PLANNING AND DEVELOPMENT SERVICES STAFF REPORT

**SUBJECT: Hampton Inn Planned Project Site Plan for City Council Approval
(2910 Jackson Avenue)
File No. SP13-002**

RE: Response to Planning
Commission Request

Project: Jackson Avenue –
Hampton Inn

SITE / GEOMETRIC PLAN

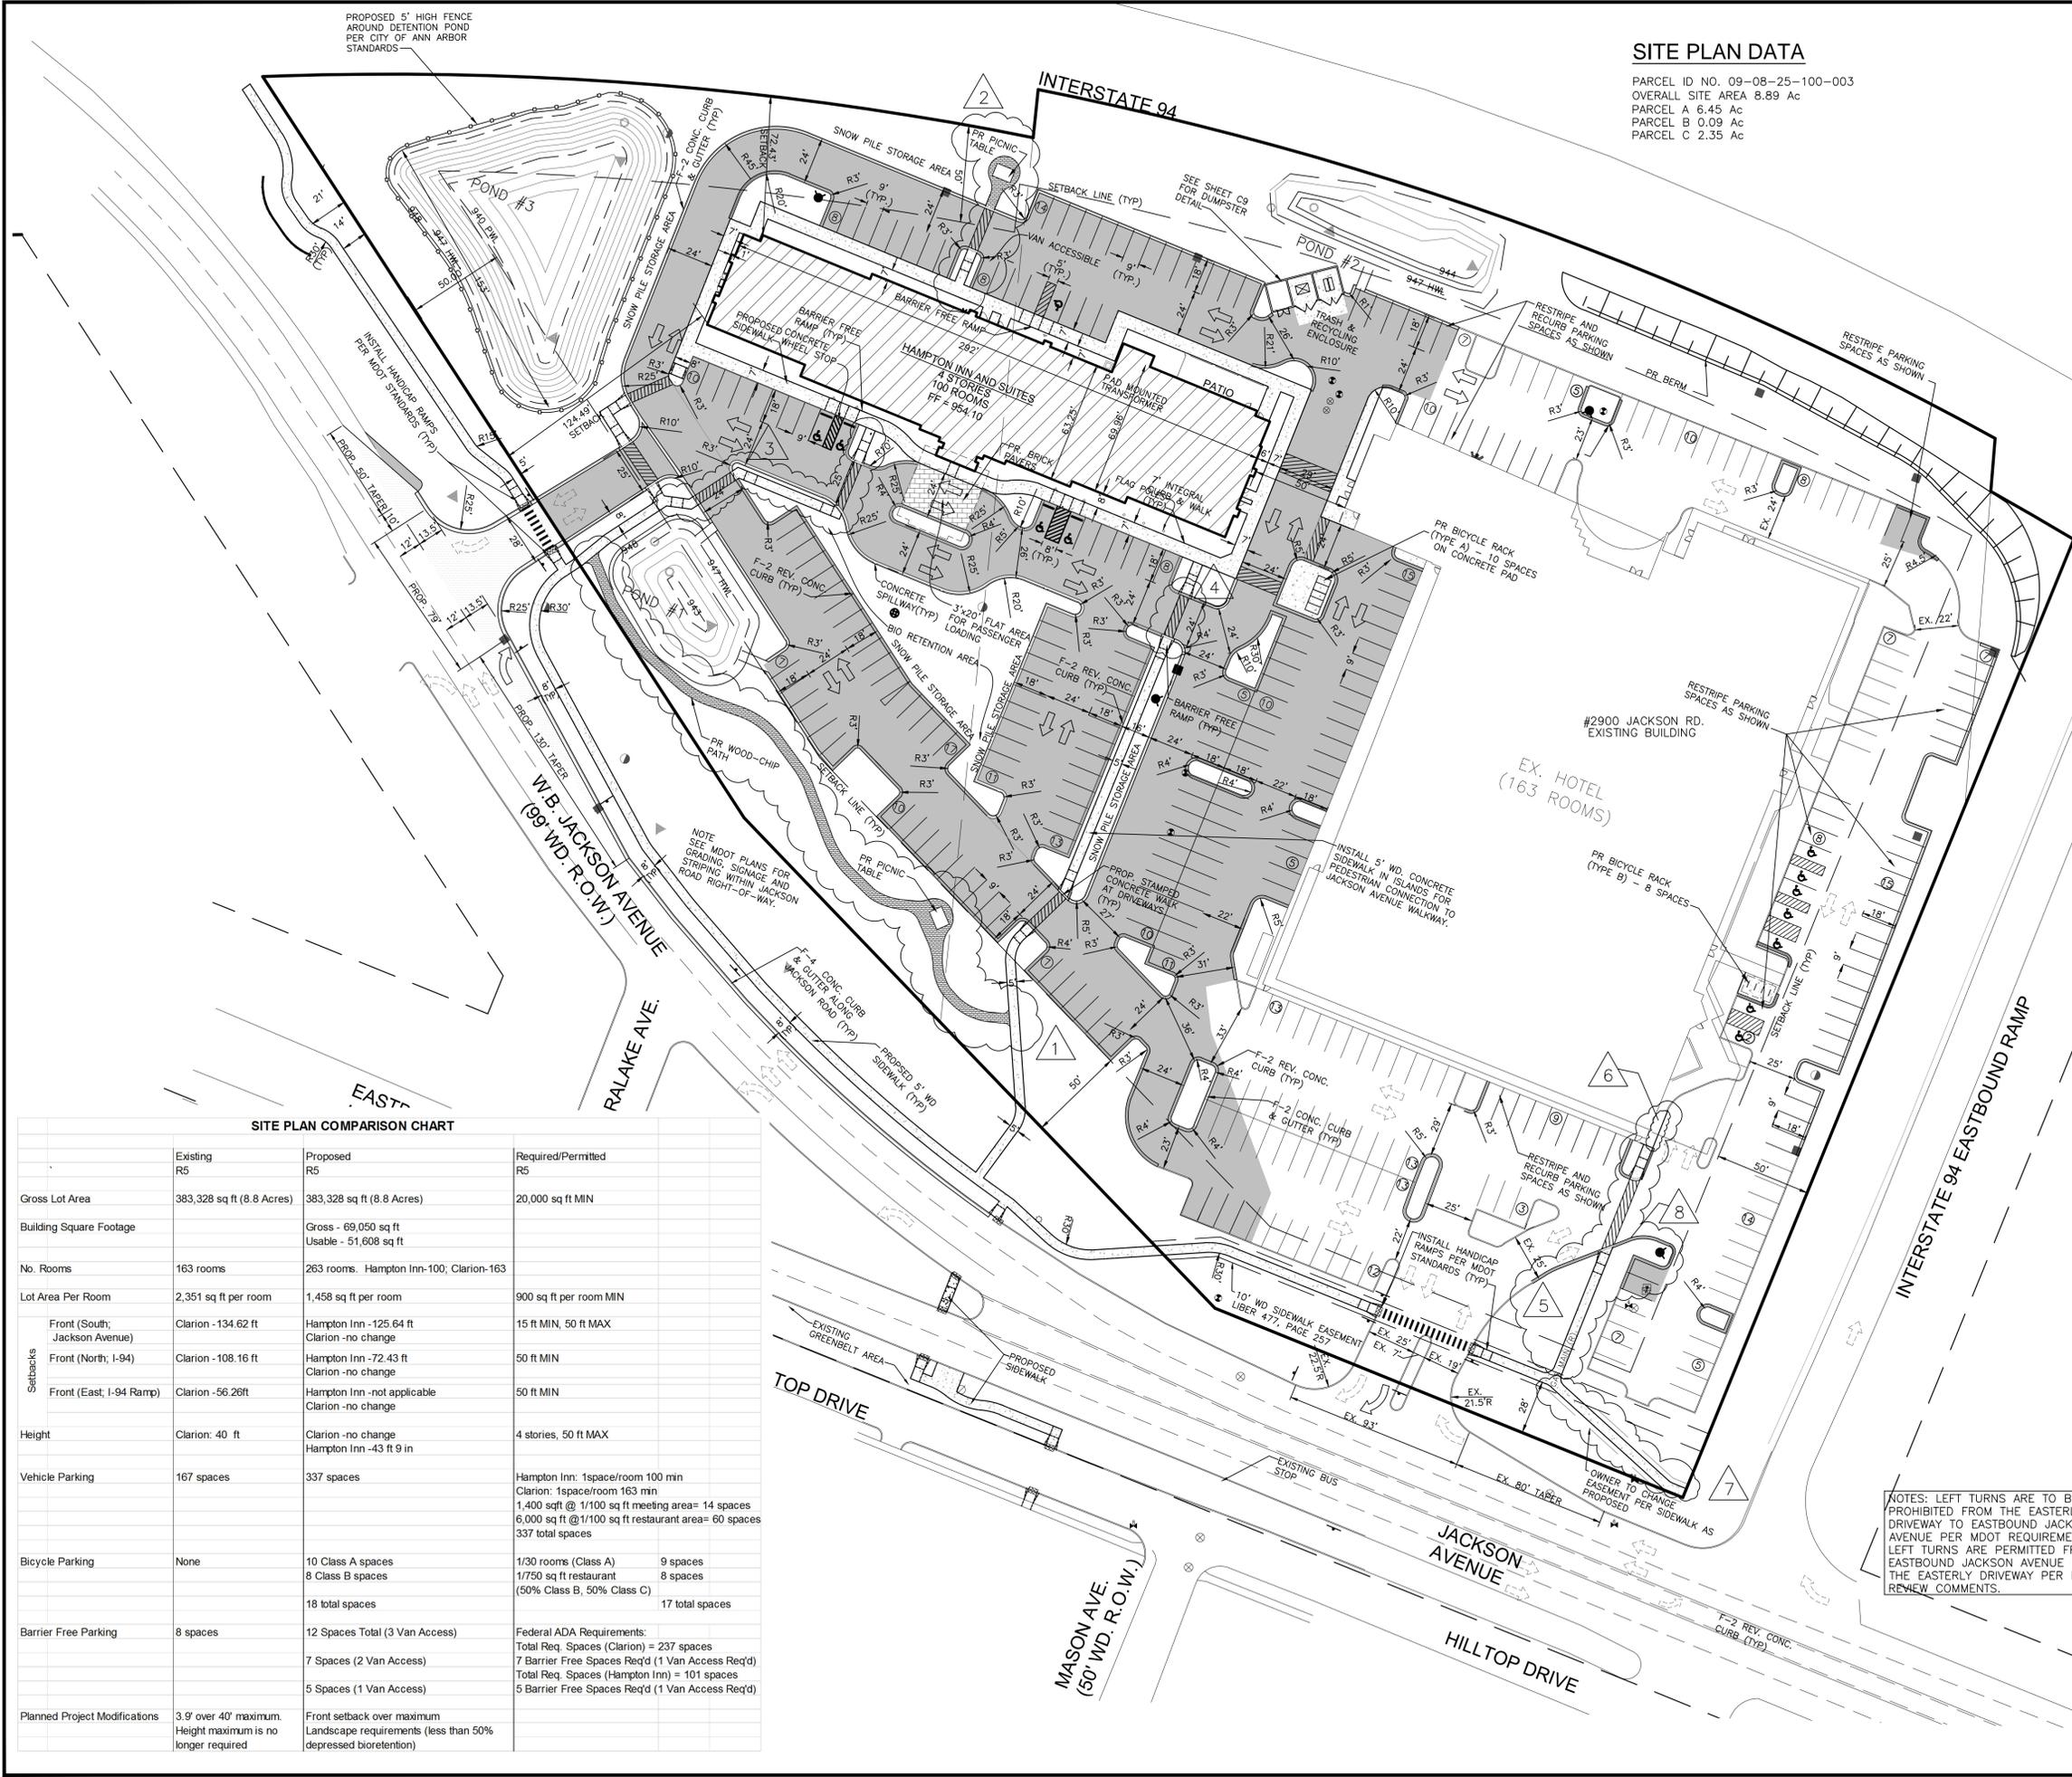
This petition was postponed at the June 18, 2013 Commission meeting to provide the petitioner an opportunity to improve the pedestrian circulation on the site in support of the planned project standards. The petitioner provided revised plans on June 28, 2013 that identify adjustments to improve the pedestrian connectivity to public sidewalks, the area immediately surrounding the site, and circulation throughout within the site, in addition to providing outdoor pedestrian amenities on the site. The revised site and landscape plans are attached, as is a letter detailing the changes. Each numbered item in the letter corresponds to a bubbled area on Sheet C4 showing the changes.

The traffic engineer also re-examined the proposed mid-block crosswalk at the central drive and confirmed this is in the most logical and safest location for the crosswalk. He recommended that the public sidewalk proposed on the east side of the site at the I-94 on-ramp be revised to terminate at the corner of the Clarion/Hampton Inn parcel, rather than the location 15-20 feet up the ramp, as shown on the previous plan. This location is closer to the street and will allow pedestrians to better see turning cars approaching.

The revised plans have not been reviewed by Systems Planning to confirm compliance with landscape and storm water detention requirements. Planning staff recommends approval of the site plan, contingent on addressing staff comments prior to City Council.

1. Wood Chip path with picnic table area along the front wooded area of the site to facilitate a walking path along the usable perimeter of the site. This path connects to the two previously proposed entrances from Jackson Avenue into the site.

2. The island at the back of the site has been modified to provide a straight pedestrian corridor across the parking area to a picnic table area.
3. We have provided an alternate pedestrian access route at the west access to cross the front parking lot in a more direct route toward the front door of the Hampton Inn hotel. This route now crosses to the center island, runs along the north side of the bio-retention area then across to the front door.

4. We have modified the center walkway in order to be a straighter more direct path toward the Hampton Inn hotel.
5. We have modified the Eastern site entrance for a direct route toward the front door of the Clarion hotel.

6. We have also provided a wider walkway underneath the porte-cochere at the front entrance to the Clarion hotel to accommodate this direct pedestrian route from Jackson Avenue.

7. We have revised the public walkway within the existing easement at the southeast corner of the property in order to facilitate a safer crossing of the entrance to I-94 if MDOT chooses to place one in the future.

8. As a part of the Clarion pedestrian entrance we revised the existing curb to eliminate excess pavement at a crossing to the front door of the hotel to facilitate a safer crossing for pedestrians.

LANDSCAPE PLAN

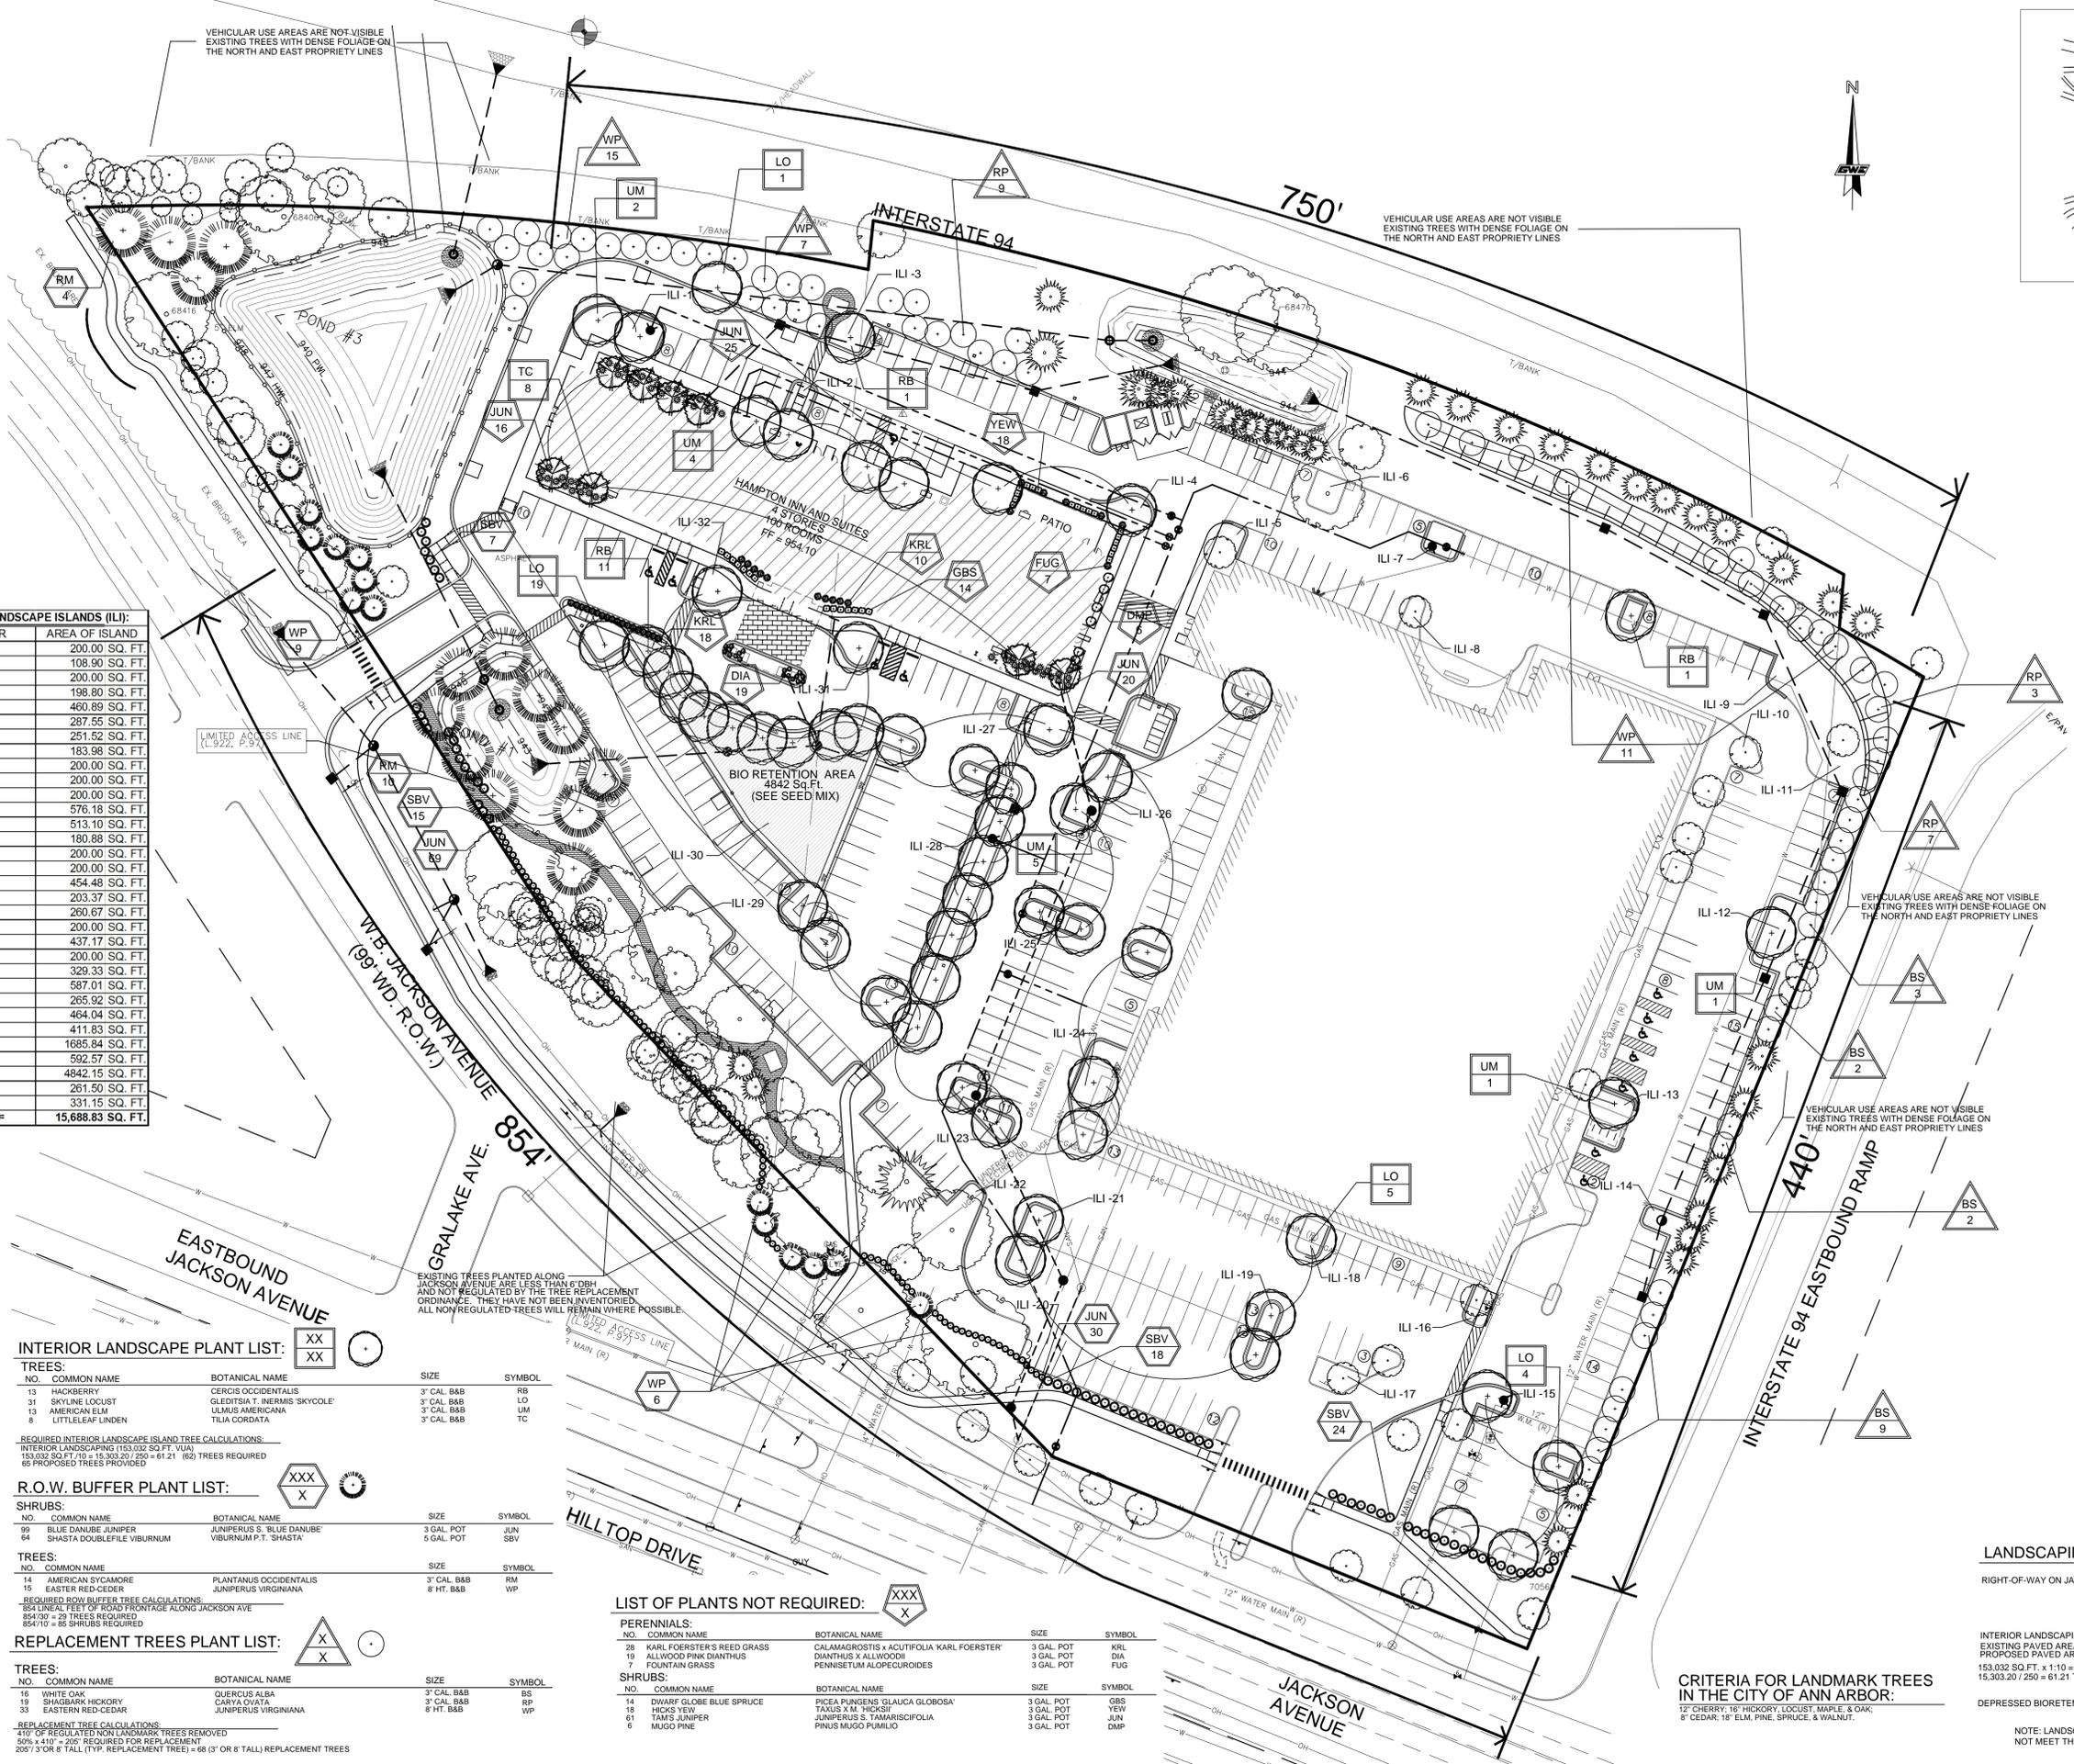
Staff recommends **approval** of the landscape modification because the proposed single large bioretention area meets the spirit and intent of the interior landscape island bioretention requirements.

NOTE: LANDSCAPE MODIFICATION APPLICATION IS BEING REQUESTED TO NOT MEET THE DEPRESSED BIORETENTION REQUIREMENTS.
